29 December 1992
Project 1736.11

Subject: Groundwater Monitoring Program
1301 Marina Village Parkway
Marina Village Development
Alameda, California

On behalf of Alameda Real Estate Investments, Inc. (AREI), Geomatrix Consultants, Inc. (Geomatrix), has prepared a groundwater monitoring program that involves installing one monitoring well and conducting quarterly groundwater monitoring at the subject property in the Marina Village Development in Alameda, California (Figure 1). The purpose of the program is to comply with Alameda County Department of Environmental Health (ACDEH) requirements for closure of underground storage tank (UST) sites.

TANKS 1 AND 2
 SITE PLAN AND GROUNDWATER WELL LOCATION MAP
 1301 (Formerly 1150) Marina Village Parkway
 Marina Village Development
 Alameda, California

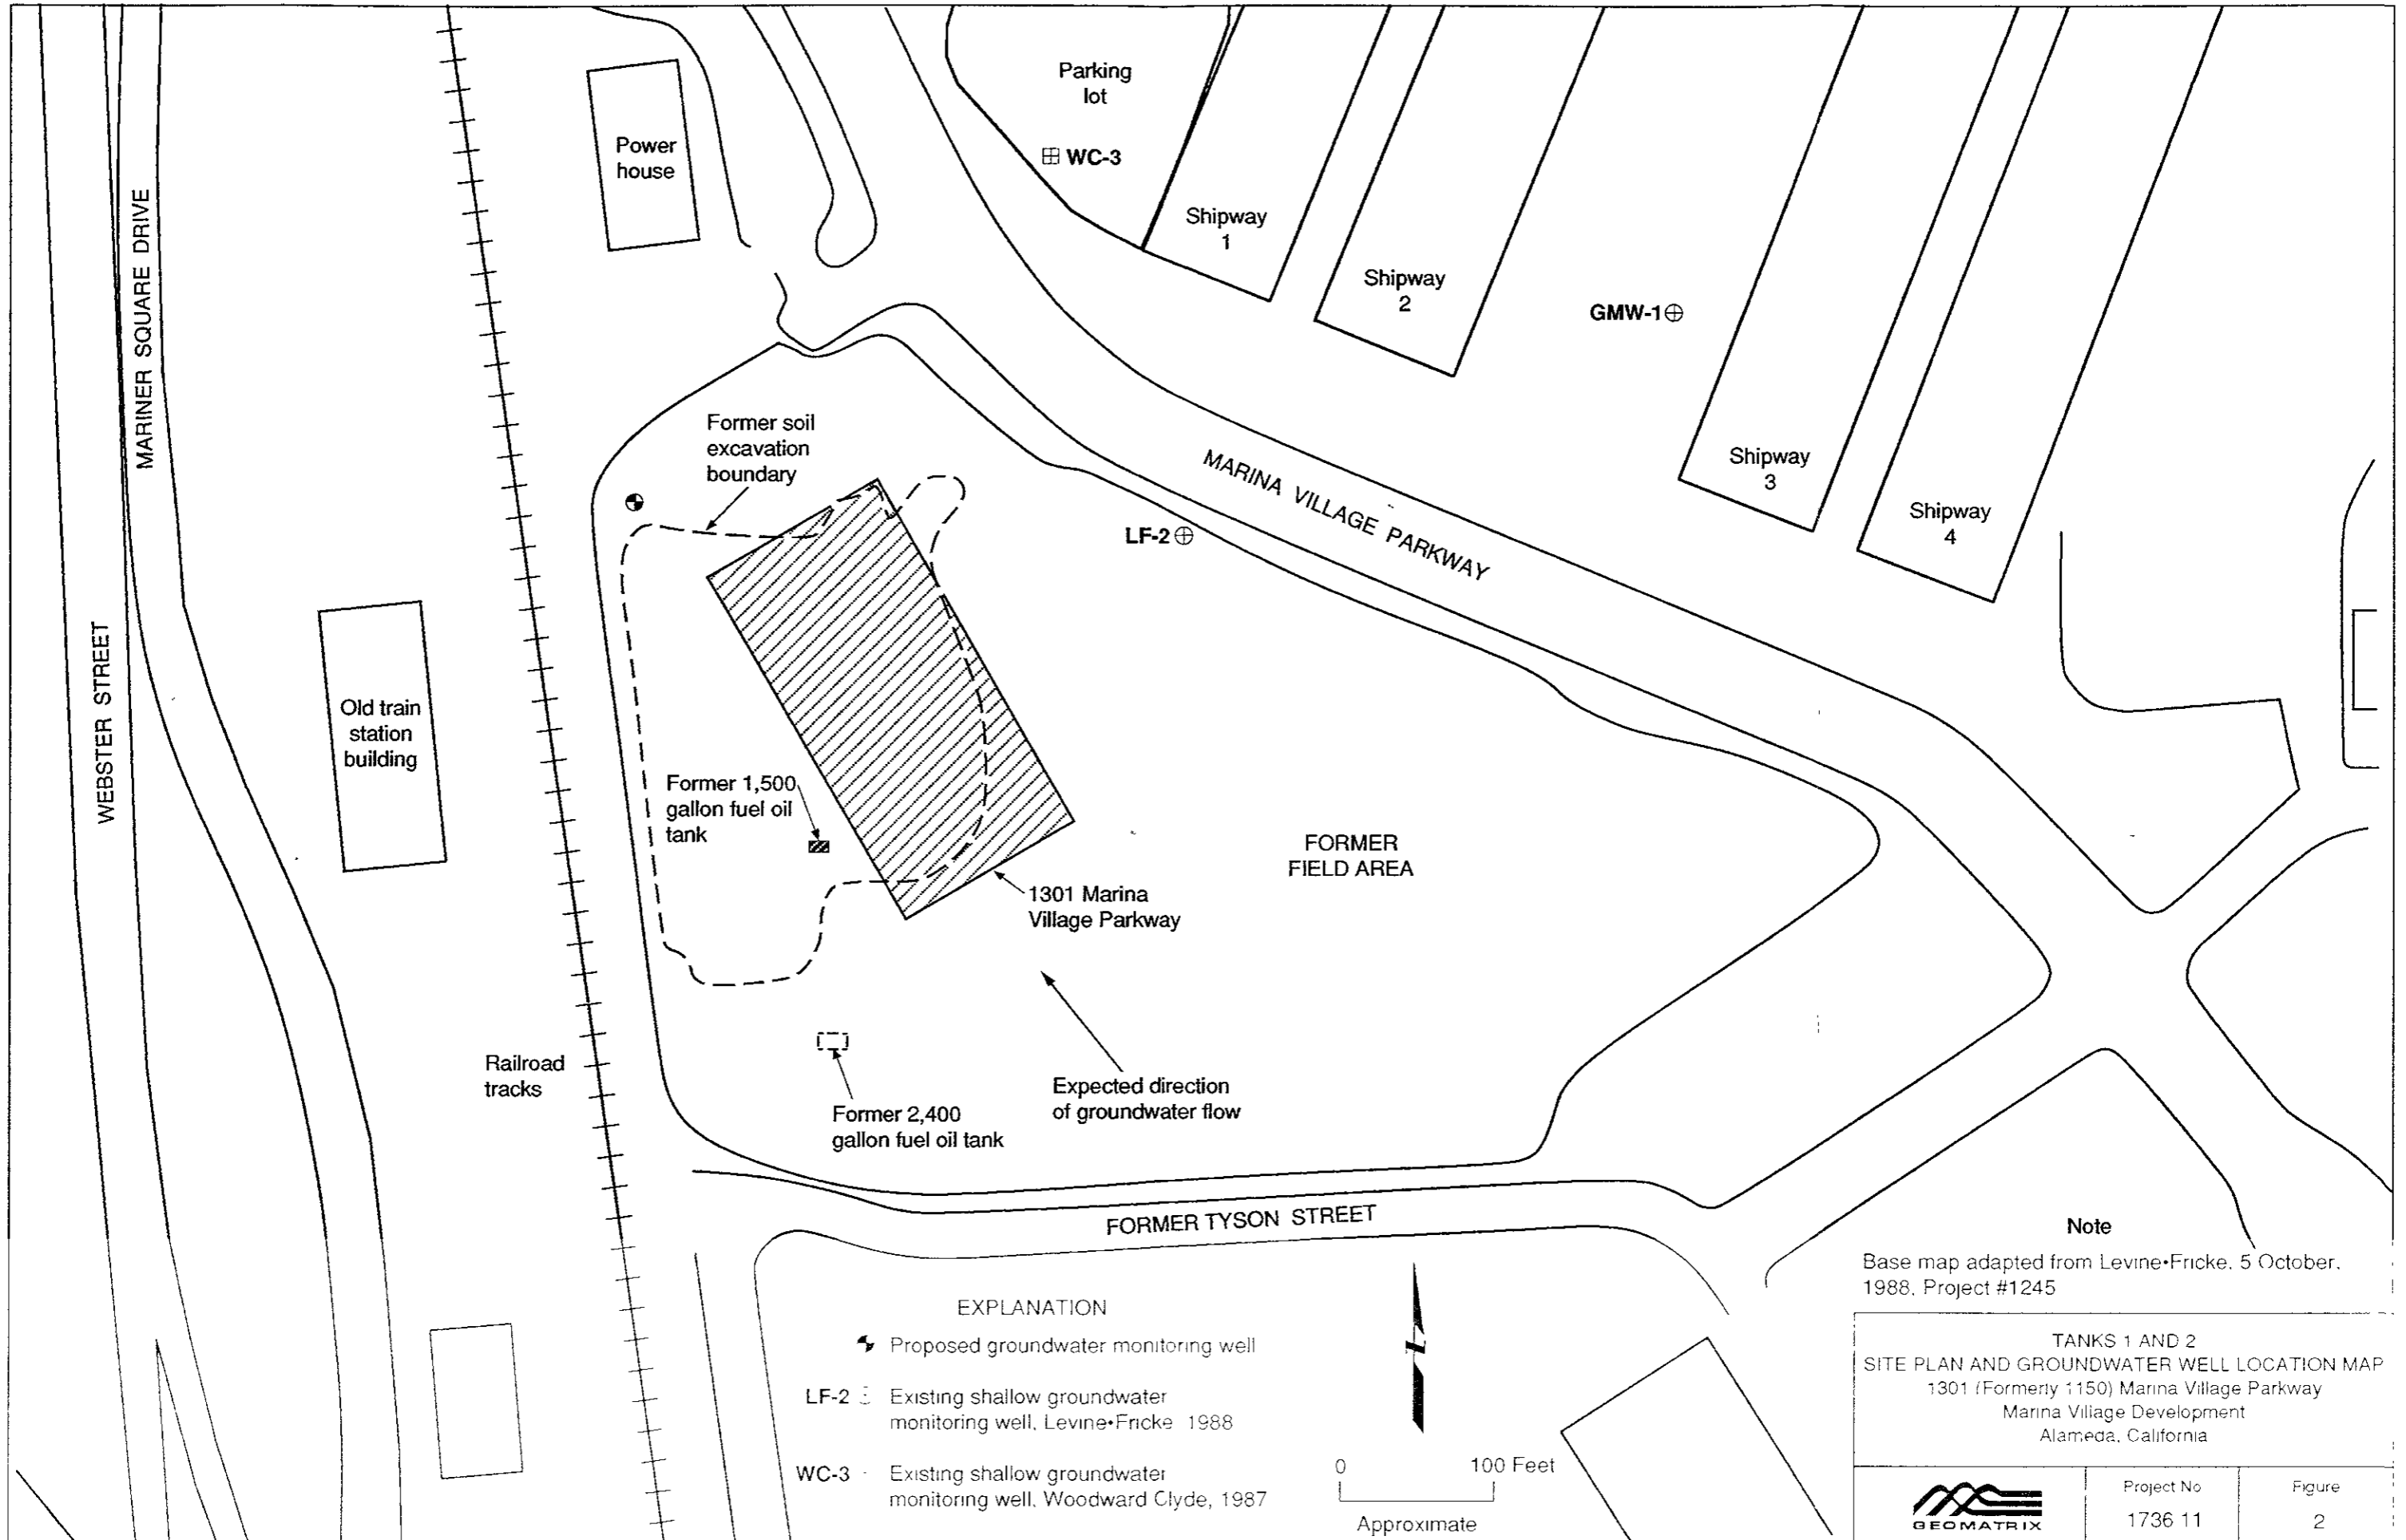
Should collect water level measurements before installing well.

Make sure screen is above water level
